**To:** Carlsbad traffic commission

**From:** Steve Linke (splinke@gmail.com)

**Date:** October 2, 2023

**Subject:** Multimodal Level of Service (MMLOS) Methodology Update (10/2/2023 Agenda Item #2)

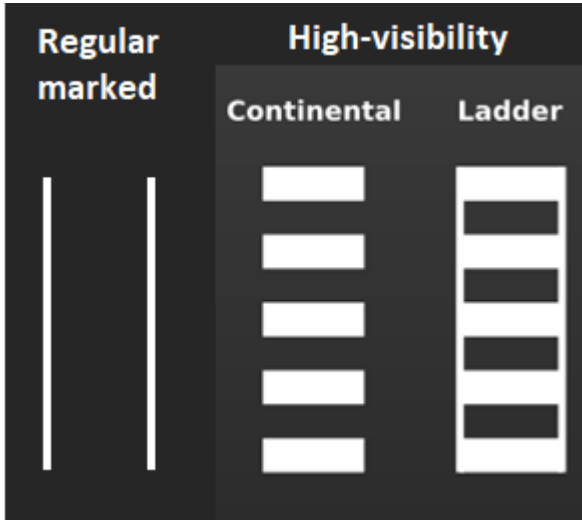
I do not recall the ad hoc committee ever endorsing a change in that criterion or a reduction in the minimum sidewalk widths below those stated in the Mobility Element, but staff’s proposed change would do just that, undermining the existing requirement:

Essential Feature: Sidewalk or path meets [Americans with Disabilities Act] unobstructed width based on Sustainable Mobility Plan (SMP) recommendations (Minimum recommended unobstructed width based on SMP is 5')

It is my understanding that the ADA requires only 3 feet with the California Building Code increasing that to 4 feet, and I am unaware of any language in the SMP that sets a minimum sidewalk width. Therefore, the references to the ADA and the SMP, and the inclusion of the 5’ “recommended” width make this change very ambiguous. It certainly sets a lower standard than the Mobility Element for the Identity and School Streets, and it also could be interpreted by developers to not even “require” a 5-foot sidewalk, since that is only “recommended”—resulting in only 3-foot or 4-foot sidewalks.

I am not sure why staff wants to make this last-minute change, but, if it is entirely related to feasibility (lack of land to expand the sidewalks) in some areas, then I would propose the following simple modification of the existing criterion, which remains more consistent with the Mobility Element:

***Essential Feature: Sidewalk width meets minimum width for typology according to the Mobility Element (or 5' if unspecified), wherever feasible***
